**WACONIA PLANNING COMMISSION MEETING AGENDA**

- 1. CALL MEETING TO ORDER AND ROLL CALL**
- 2. ADOPT AGENDA**
- 3. APPROVAL OF MINUTES**
  - 1) February 5, 2026, Planning Commission Meeting Minutes
- 4. NEW BUSINESS**
  - 1) **PUBLIC HEARING – Woodland Trail Preliminary Plat, & PUD Zoning Request– 9350 Airport Road**

The City of Waconia staff have reviewed the proposed Preliminary Plat application for the Woodland Trail residential development drafted by Champion Engineering Services, Inc. dated December 20th, 2025, and provide the following review and comments:

PRELIMINARY PLAT OVERALL  
 SHEET NO. 3 OF 27 SHEETS  
 PROJECT NO: 25-019  
 DATE: 12/20/2025

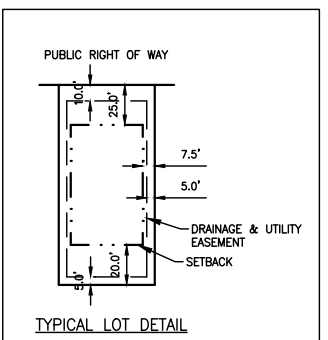
Note: All parcels shall be subject to the 50 ft. setback from the future County Road 92 corridor. The plans show a 40 ft. setback some consideration should be given that this is going to be a very busy corridor when constructed this should also include the additional landscaping requirements.

**PRELIMINARY LANDSCAPE AND RESTORATION PLAN**

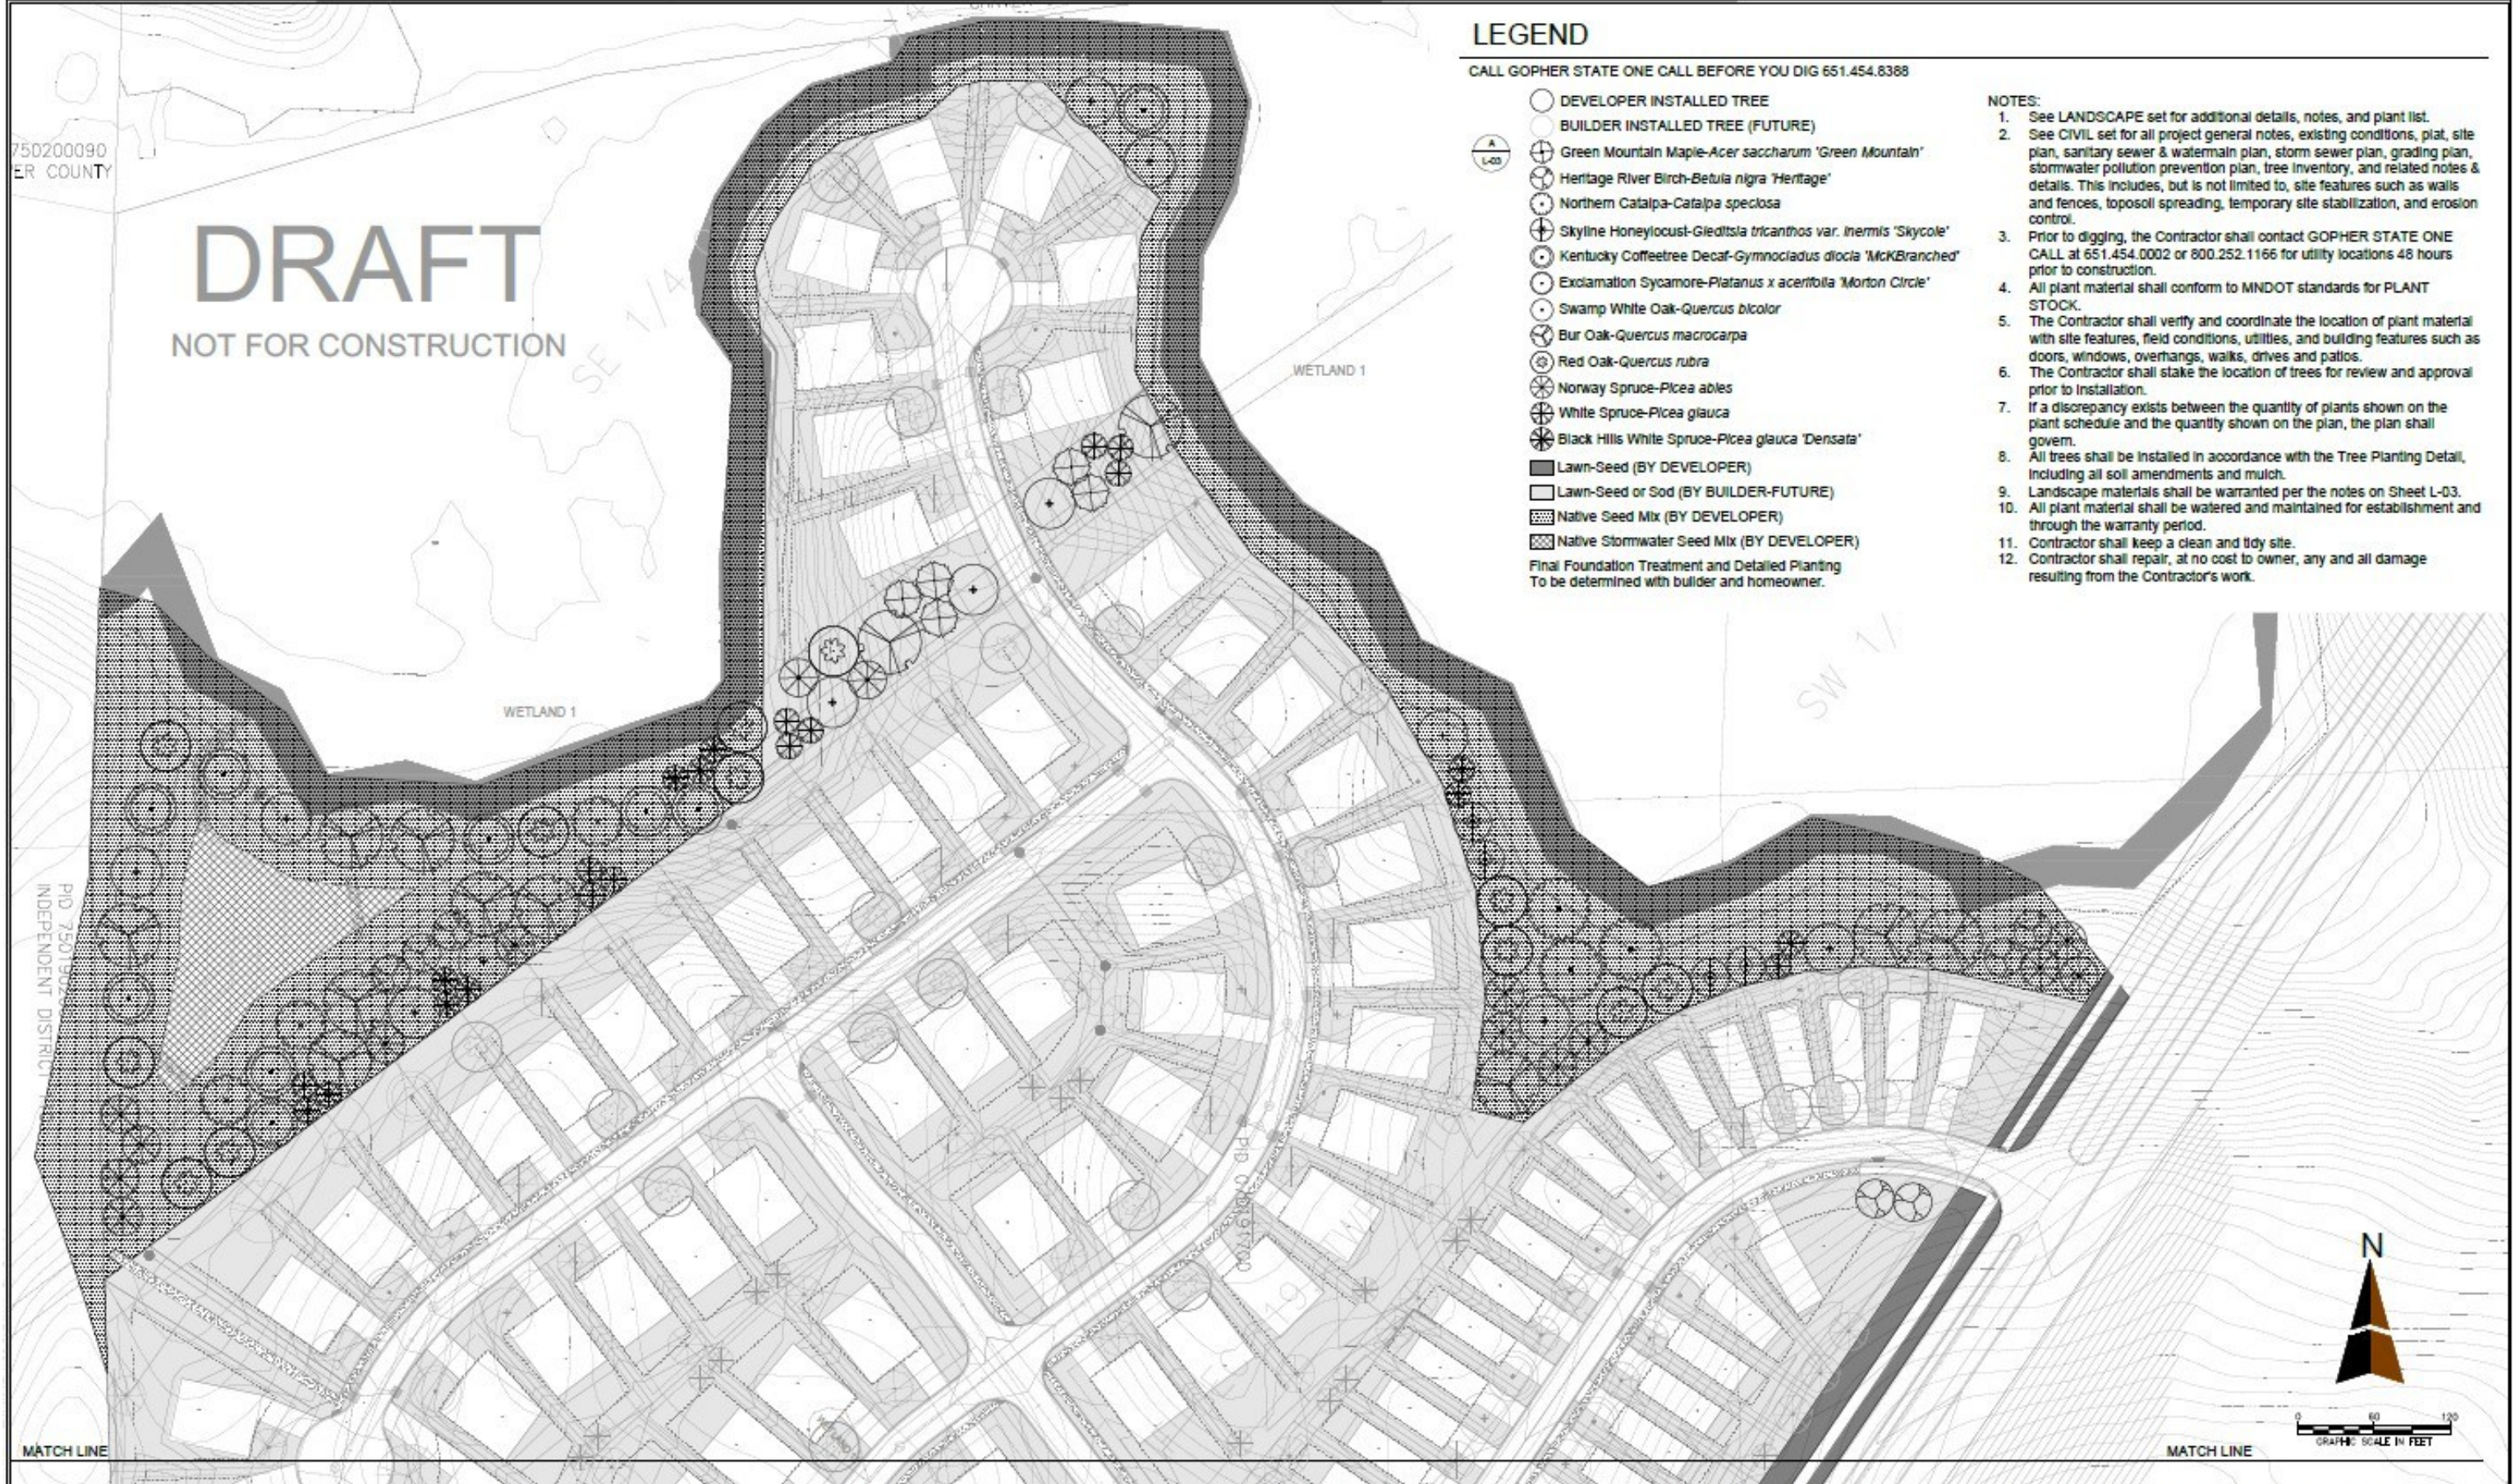
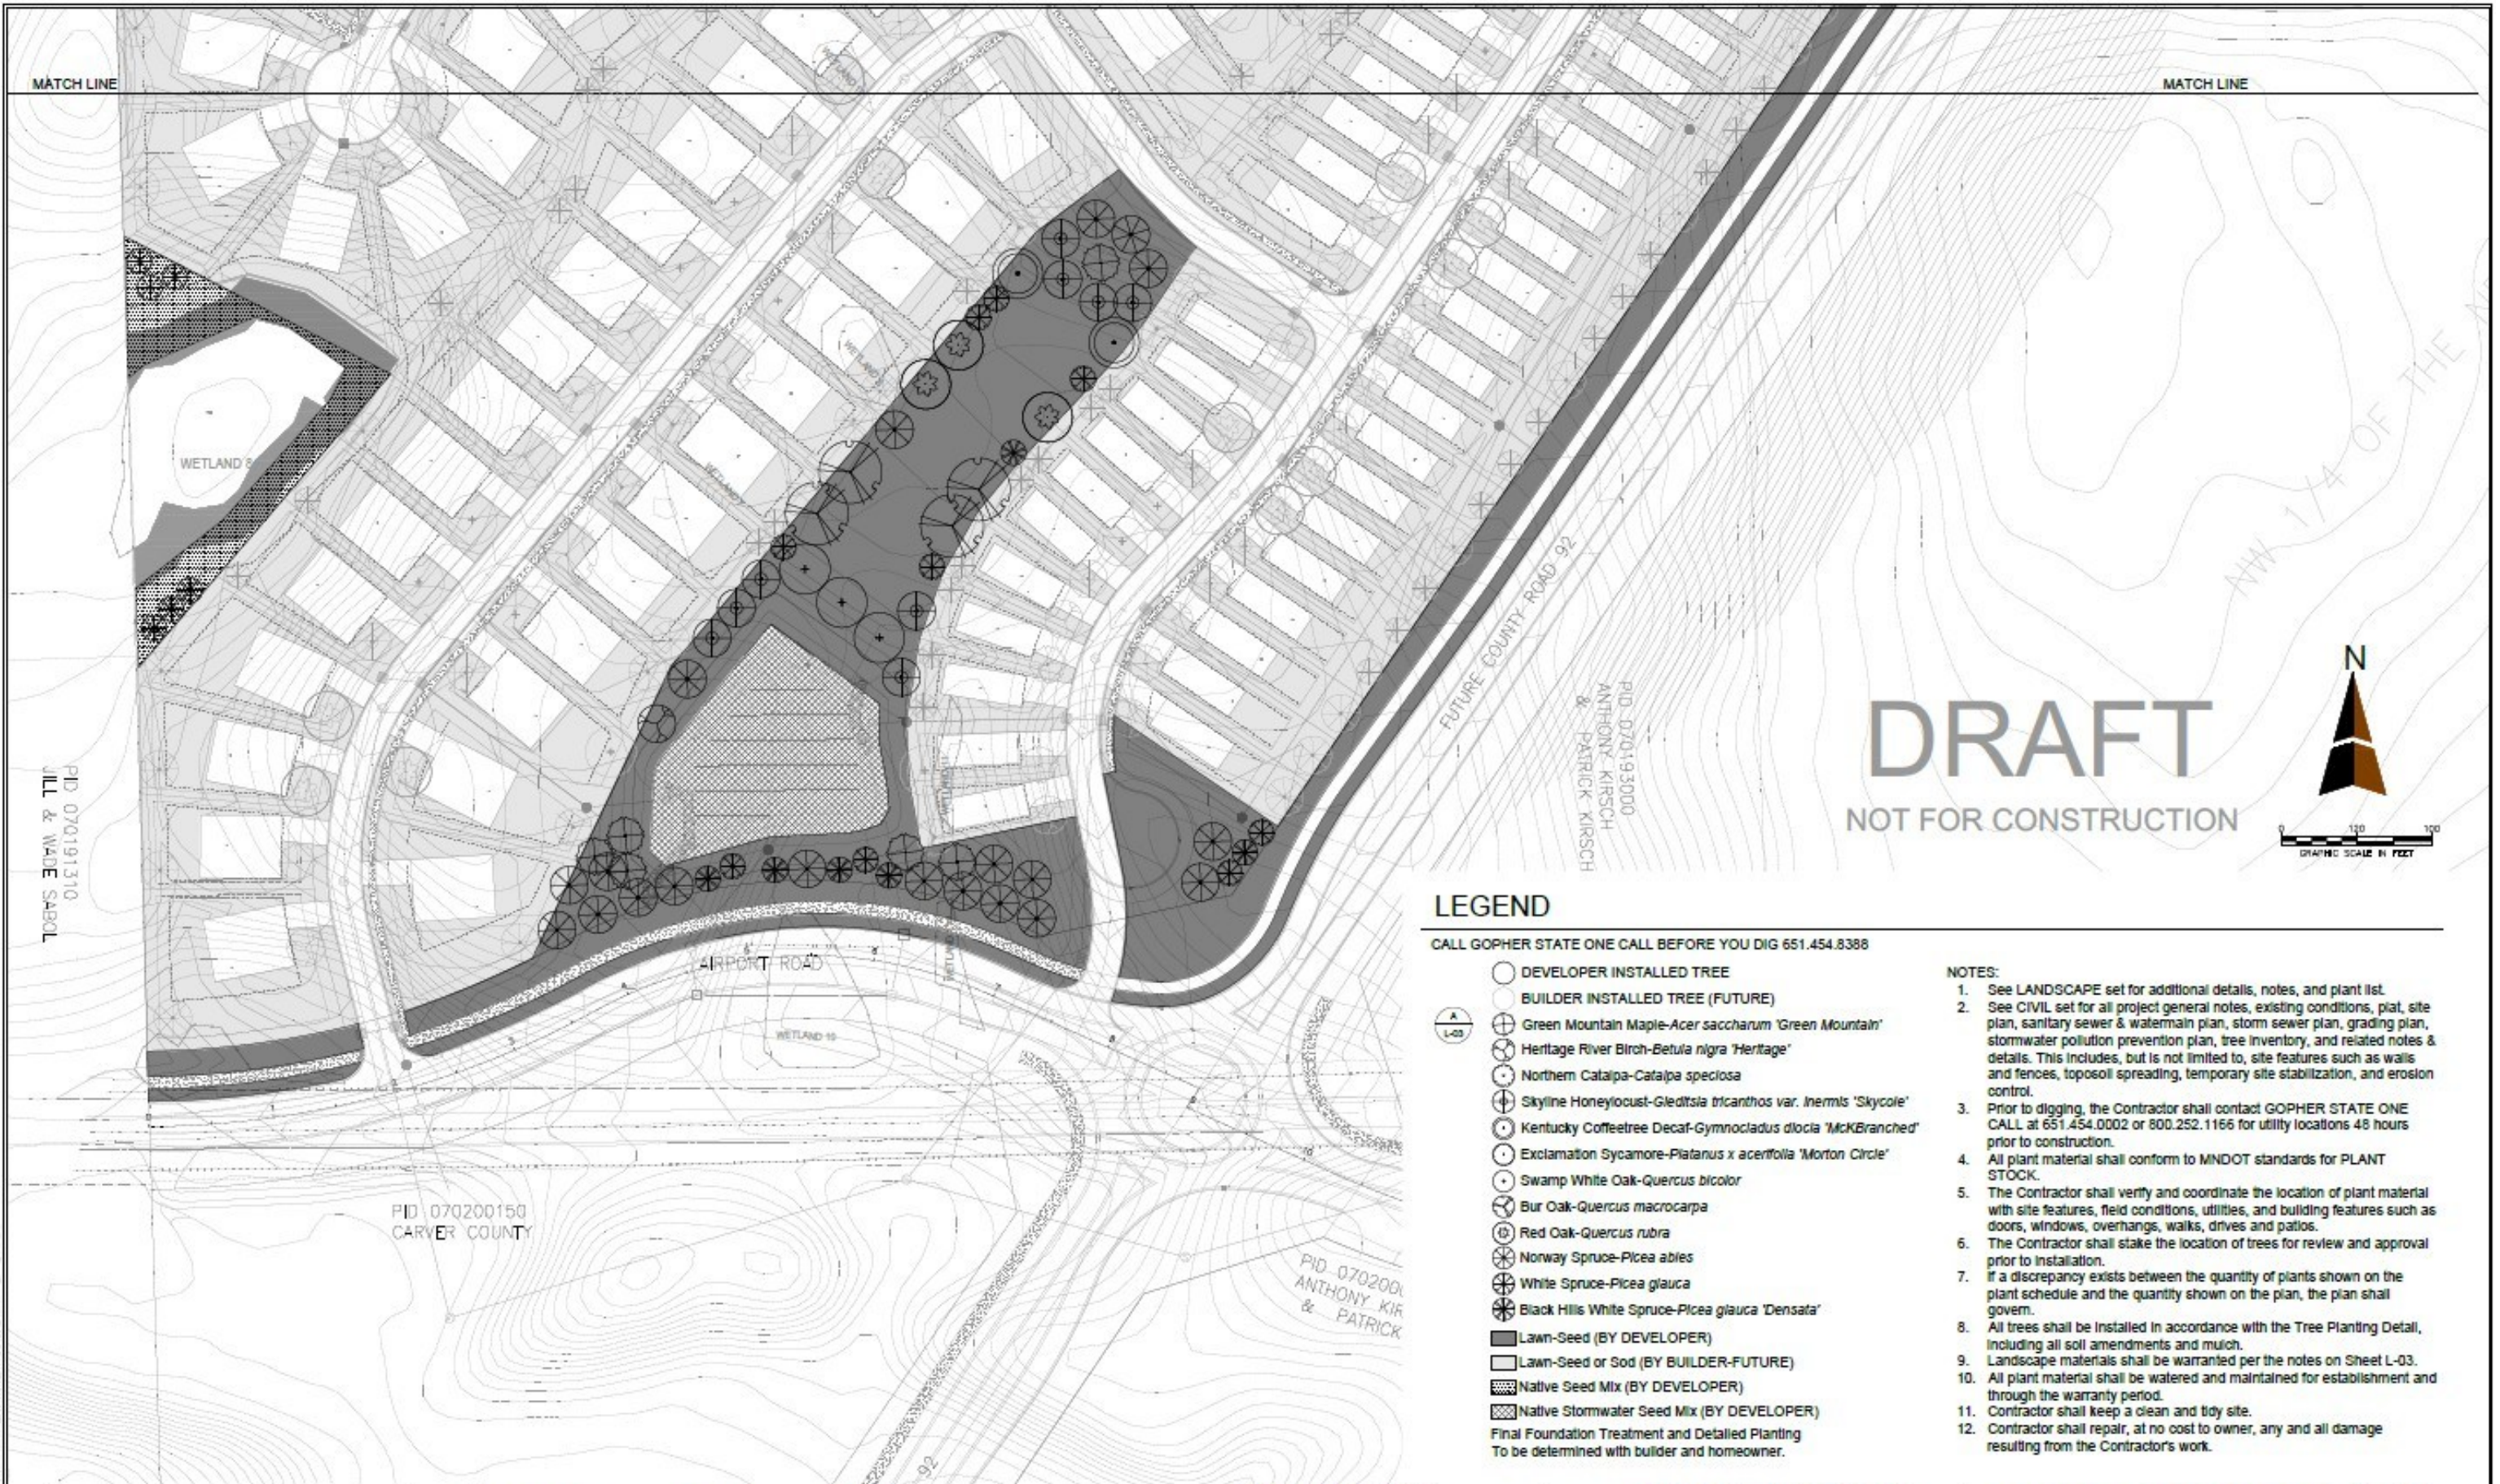
Planting strips and/or earth berms shall be included in the landscape plan set along the future County Road 92 corridor and on private property along Airport Road screening the residential home sites from the road right of way.

10. The landscape plan indicates numerous tree plantings within the gas line easement. The applicant shall provide additional documentation that the proposed plantings are allowed within the easement area.

9. A planting strip and/or earth berm, not exceeding a slope of 3:1, shall be placed along the future County Road 92 corridor and between the proposed home sites and Airport Road. City staff shall review and approve the final plantings strip or earth berm for consistency with this standard.
